Plug and Abandon

Wellname: **RESLER YATES STATE #367**

Action 524500

Operator: MEWBOURNE OIL CO P.O. Box 5270 Hobbs, NM 88241	OGRID: 14744
	Action Number: 524500
	Action Type: [C-103] NOI Plug & Abandon (C-103F)

RESLER YATES STATE #367 P&A Schematic

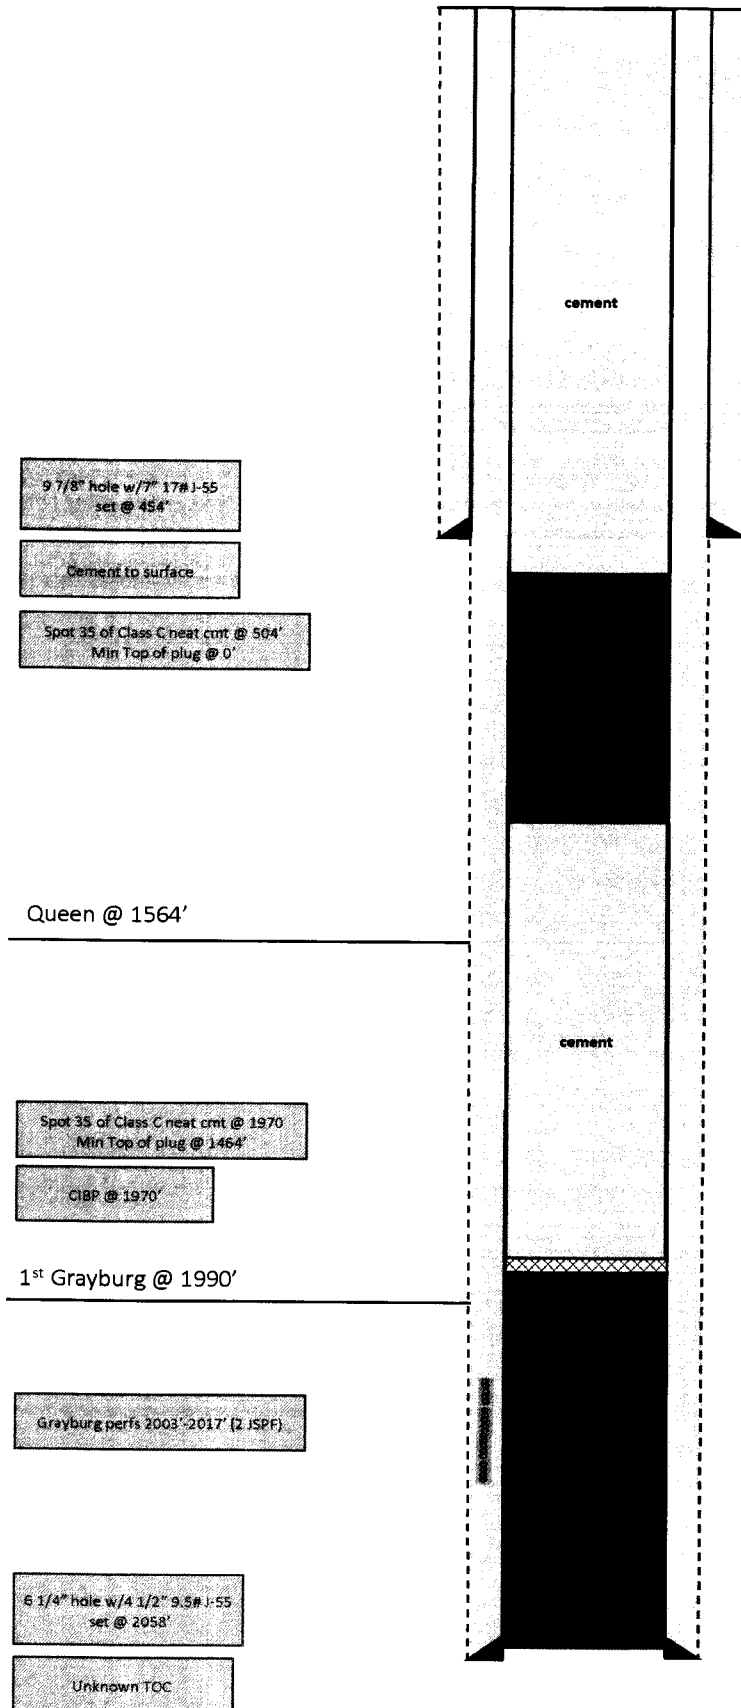
Created By	Condition	Condition Date
loren.diede	Notify the OCD inspection supervisor via email 24 hours prior to beginning Plug & Abandon (P&A) operations.	11/14/2025
loren.diede	NMOCD does not consider this well to be within the LPCH restricted area and an above ground P&A marker is required. NMOCD requires that plug(s) be added to cover the 7 Rivers = (965') and Yates = (605') formation tops. Submit photo and GPS coordinates of the P&A marker with the final P&A reports. The API# on the marker is to be clearly legible. Run CBL from CIBP to surface. Submit the CBL tif file to NMOCD for uploading into the Well Log File.	11/14/2025
